Coastal Access Modification Report SCS MR1

Proposed changes to the submitted King Charles III England Coast Path proposals for Silecroft to Silverdale

Location affected: Abbot Hall, Kents Bank, Cumbria

Natural England's Modification Report to the Secretary of State

Map SCS - MR1a - Abbot Hall

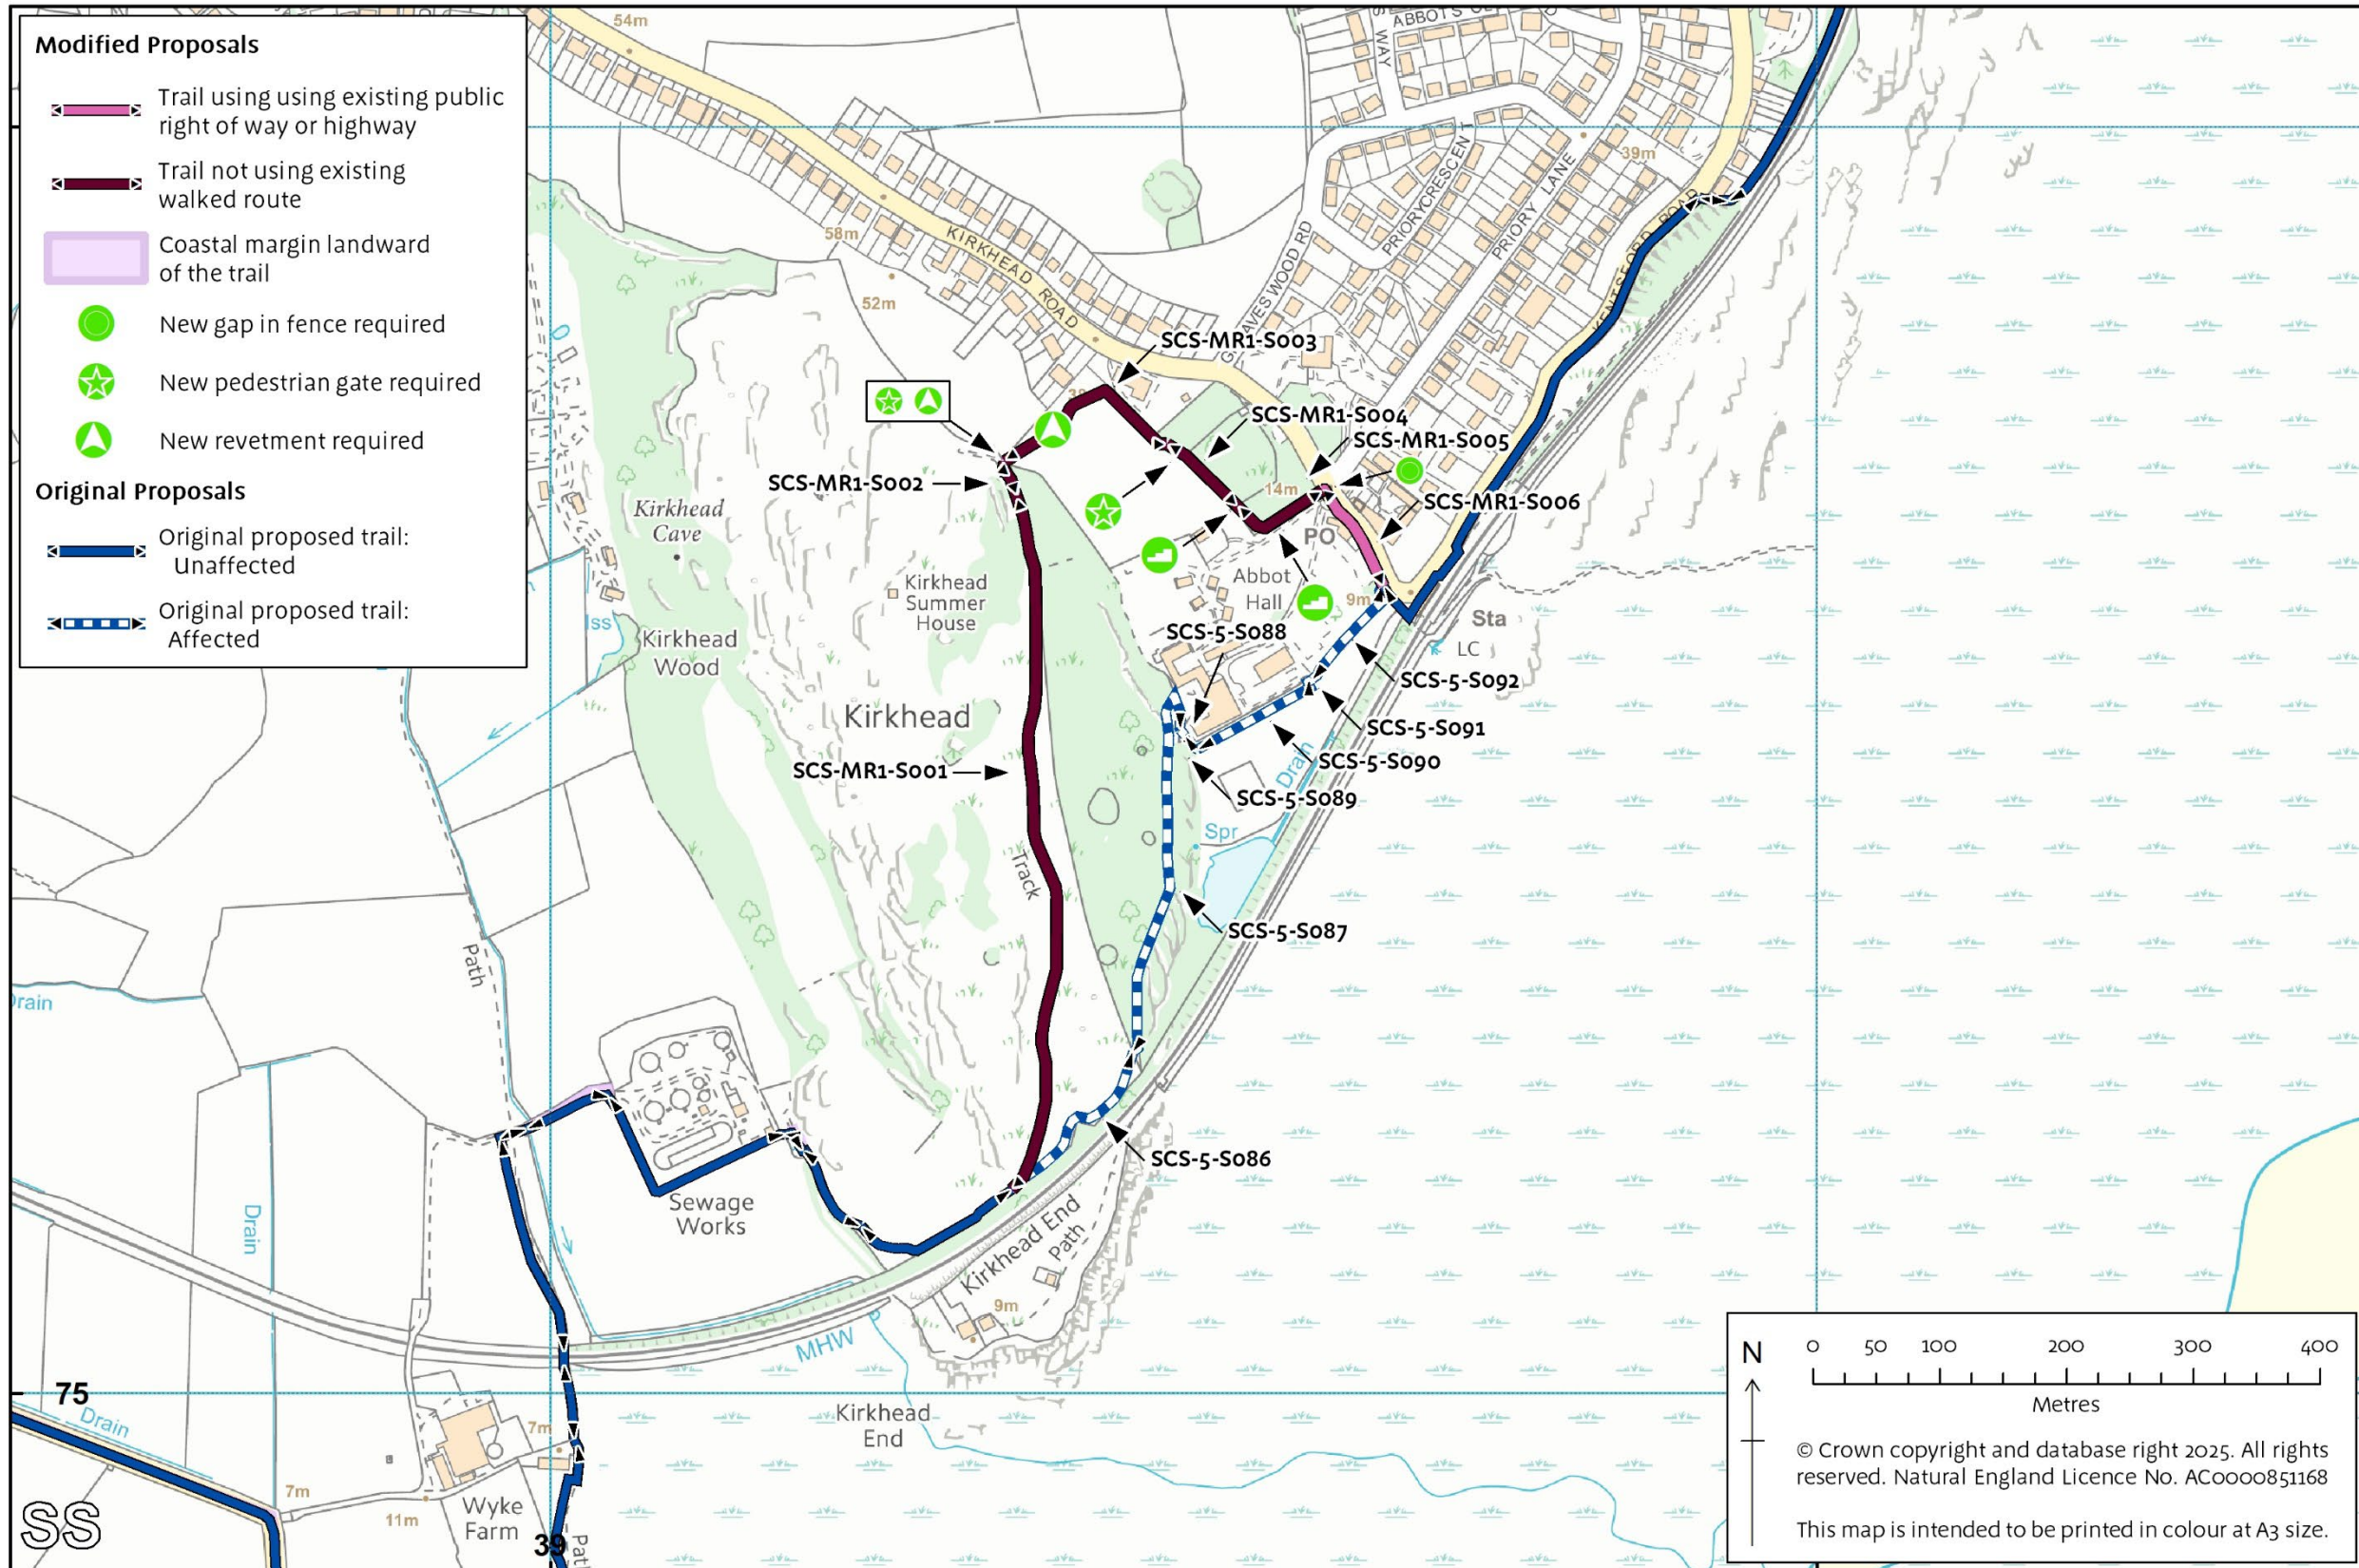
A.2.1 Our proposal (see map MR1a) is, from west to east, to re-route the path shown as the eastern end of SCS-5-S086 and SCS-5-S087 to SCS-5-S092 in our original report. The realigned trail would extend for a length of approximately 975 metres, at a maximum of 230 metres north-westward of the original route proposed.

A.2.2 The modified trail would follow an existing rough track over Kirkhead, generally northwards, before crossing the upper part of a field northwest of Abbot Hall and entering smaller blocks of woodland between Abbot Hall and Kirkhead Road. It would then follow a roadside pavement in a southeasterly direction, joining with the originally proposed route at Kents Bank station.

A.2.11 We have chosen not to make any additional roll-back proposals in this modification report. Accordingly, the route is to be at the centre of the line shown on map SCS-MR1a as the proposed modified route of the trail.

Map SCS - MR1b - Abbot Hall - Key Statutory Environmental Designations

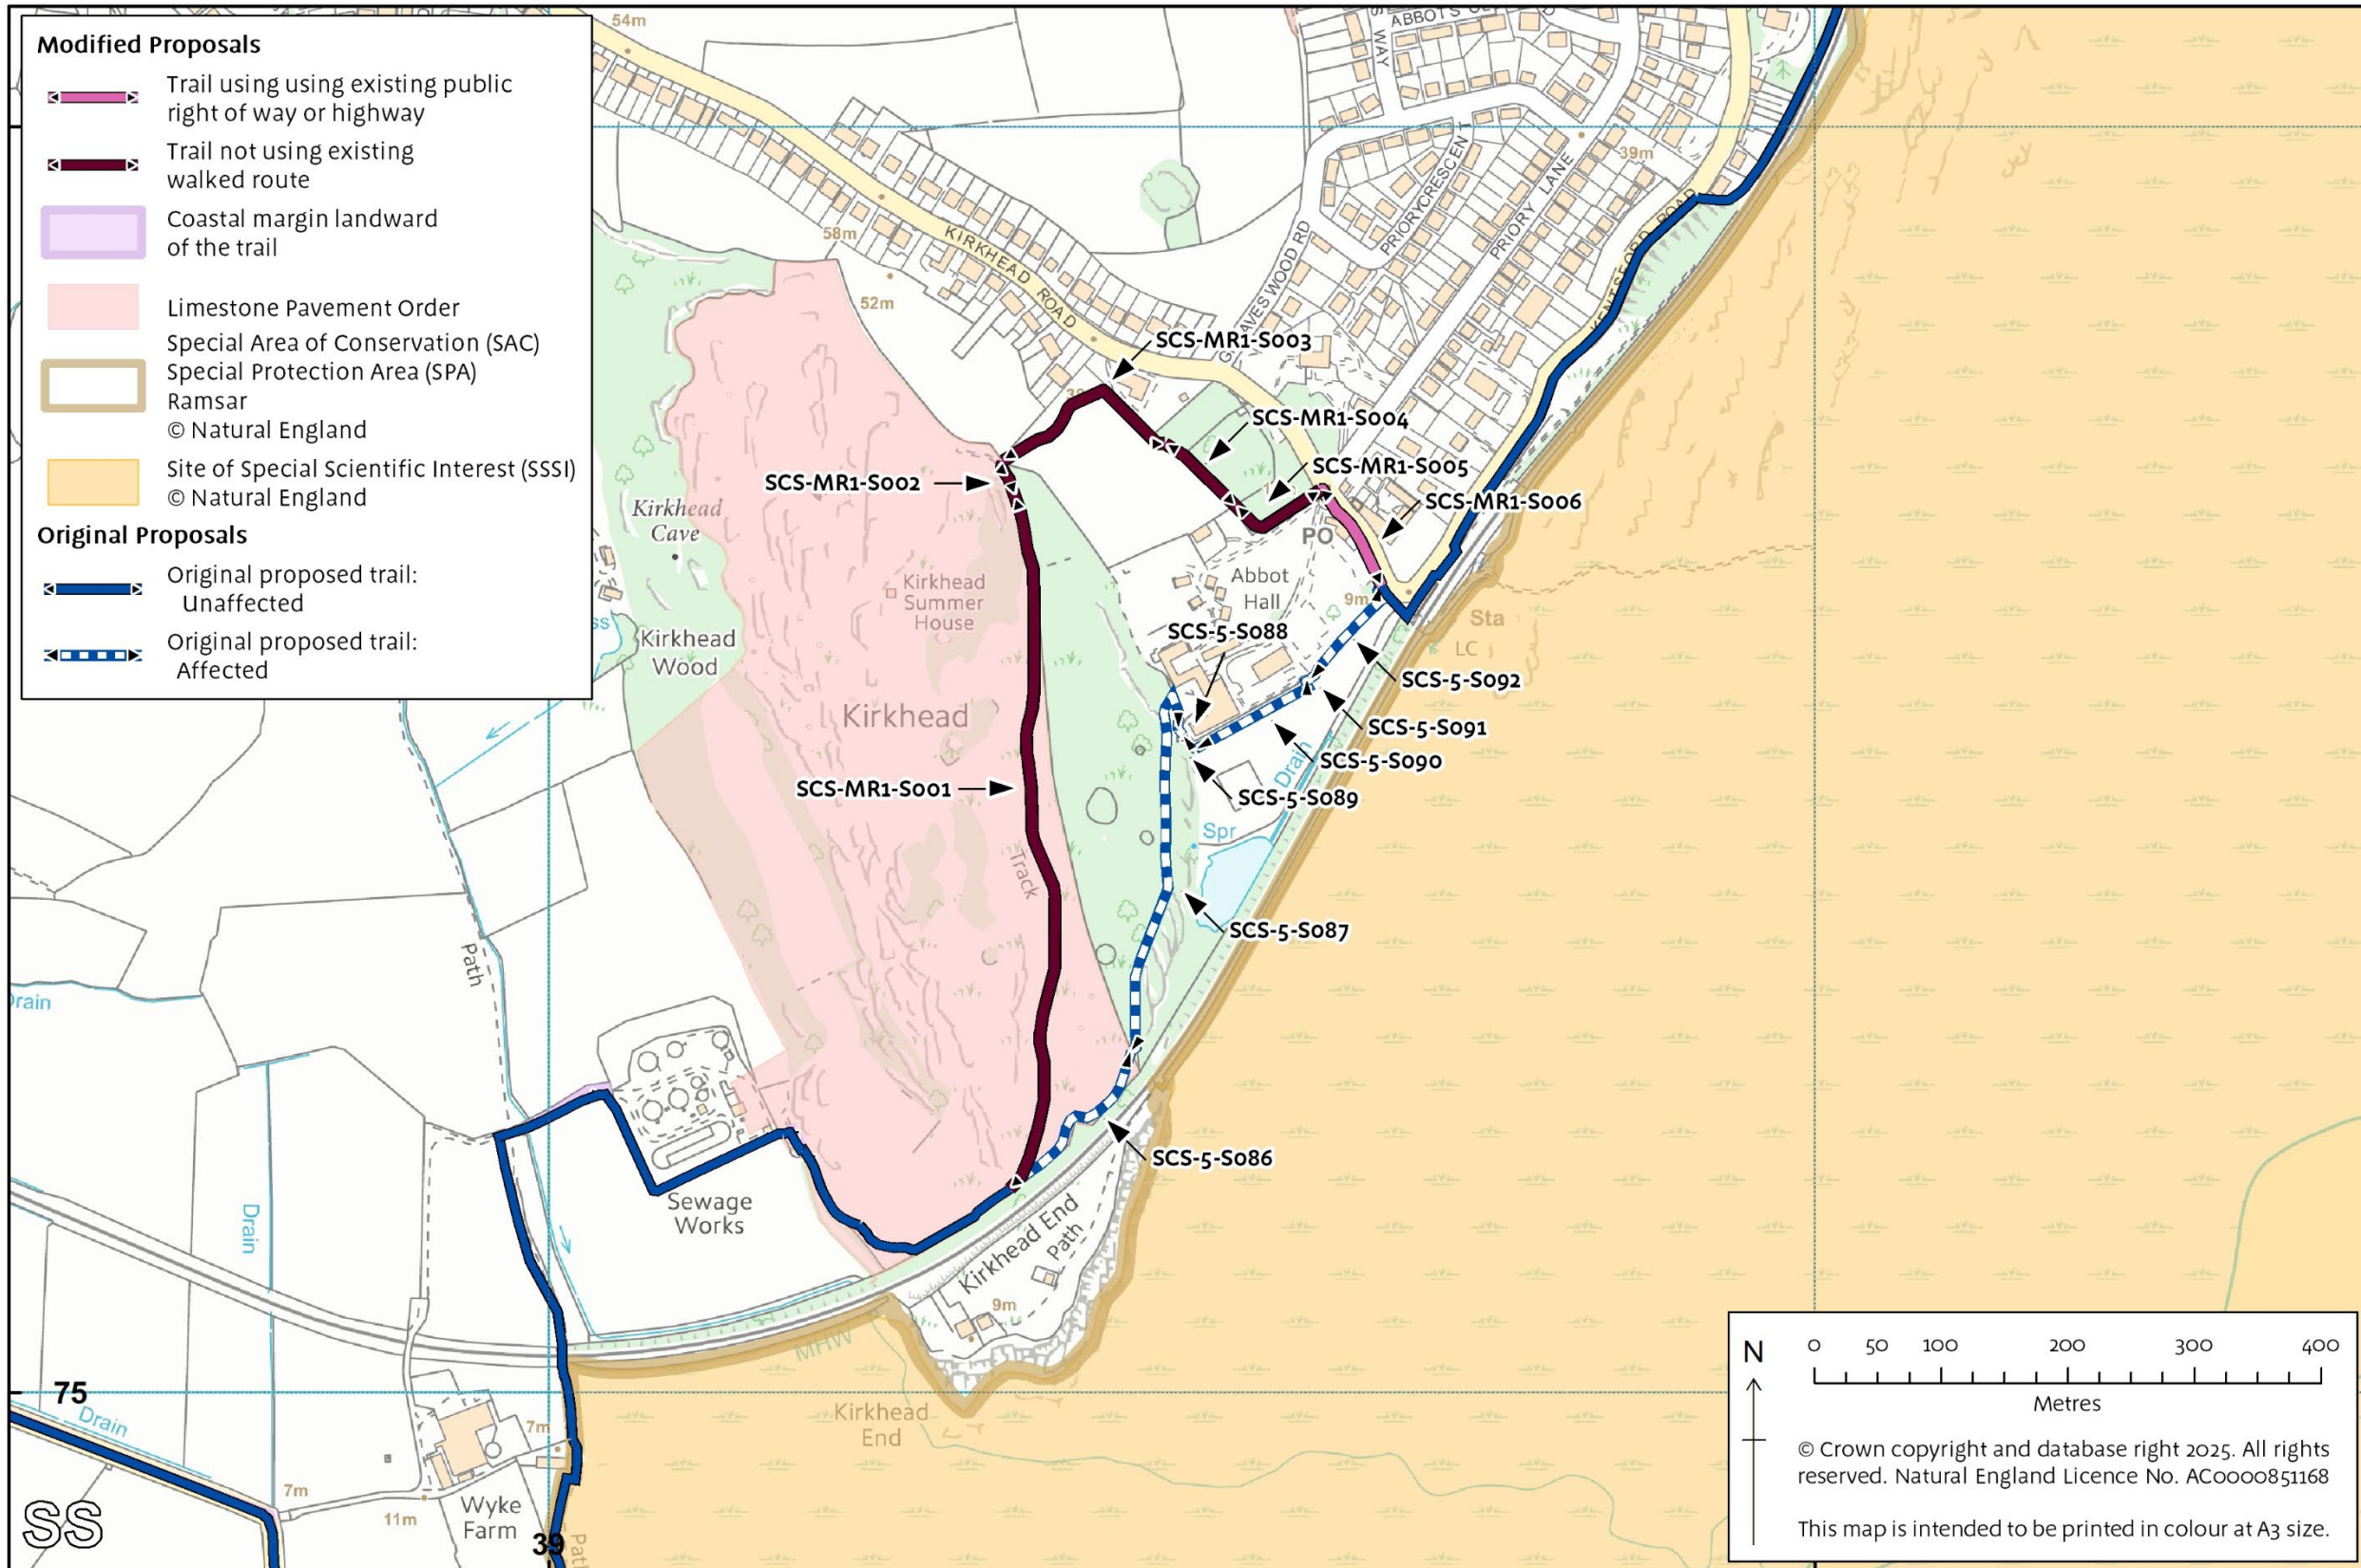
A.2.3 The modified route passes through or close to the following protected areas:

- Duddon Estuary and Morecambe Bay Special Protection Area/Ramsar site: The modified route would be close to, but entirely outside of the boundary of these protected sites.
- Morecambe Bay Special Area of Conservation: As above.
- Morecambe Bay Site of Special Scientific Interest. As above, the modified route would be close to, but entirely outside the boundary of this protected site.
- The modified route would take walkers further away from these protected sites, whilst providing more elevated views out to the estuary in places.

- Kirkhead Limestone Pavement Order area: The modified route would remain with the boundaries of this area for a greater distance than was the case with the original proposals. However, little limestone is exposed along the proposed route, and no establishment works are intended that would have any impact on the protected limestone, either exposed or buried. Any directional signage required will be carefully sited in deeper soils.

Refer to 'Key Statutory Environmental Designations' maps below – SCS-MR1b

A.2.4 Natural England is therefore satisfied that modifying its proposals in the way described in this report will not lead to them having an adverse effect on the site integrity of the Morecambe Bay and Duddon Estuary Special Protection Area/Ramsar site, and is fully compatible with conservation of the Kirkhead Limestone Protection Order area and Morecambe Bay Site of Special Scientific Interest.
